pullup-resistance for processor card SA2 (in case of interface problems)	Förster Technik GmbH	Zeichnungs-Nr. ski190a	Blatt 1
Darstellung	9.9.99	Ruh			gezeichnet	Datum 28.07.99	Versions-Nr. 1
Änderung	Ind.	Datum	Name		Name Seeger

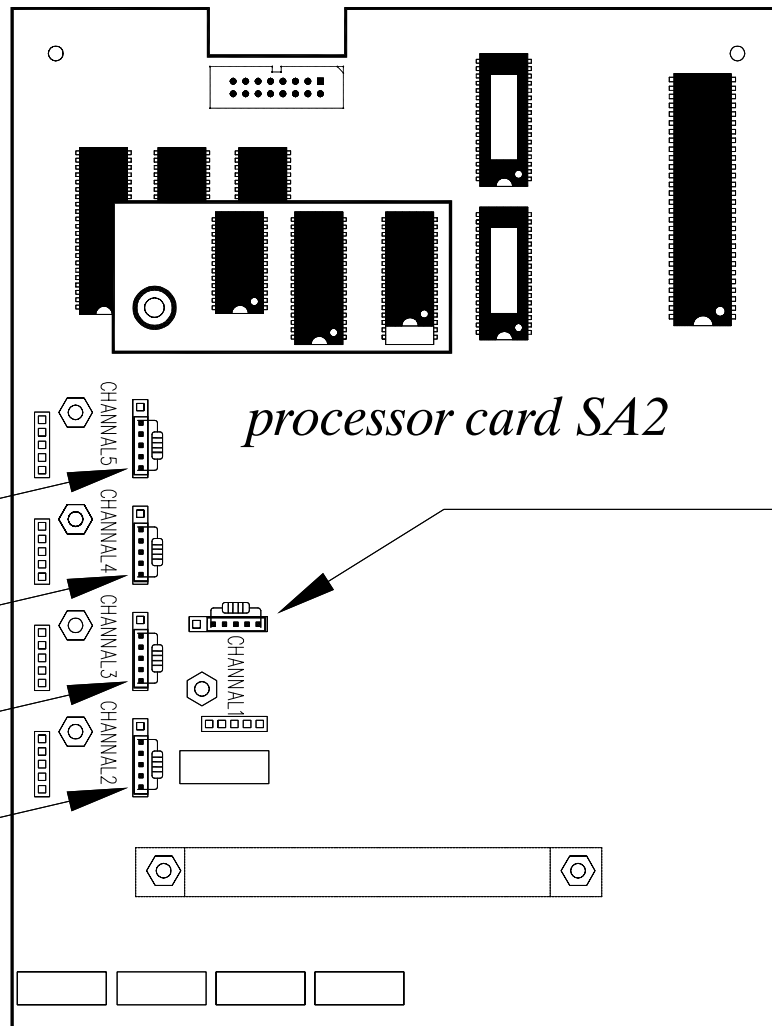
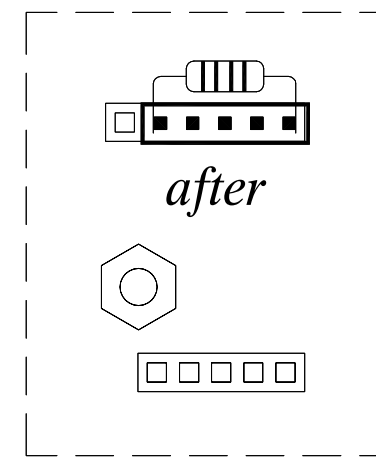
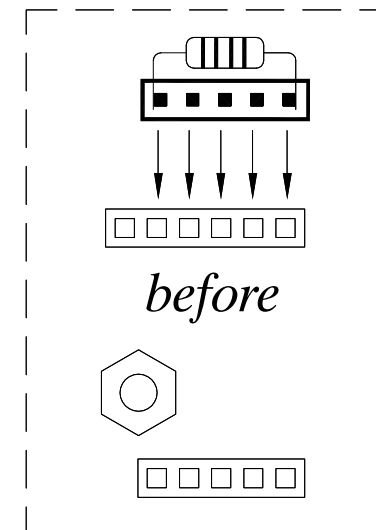
*each interface channel which is not used (card slot without interface card)
has to be equipped with a pullup - resistance, in order to guarantee
a faultless operation of the interfaces*

*pullup-resistance (47K/0,25W)
with socket (5 pin)*
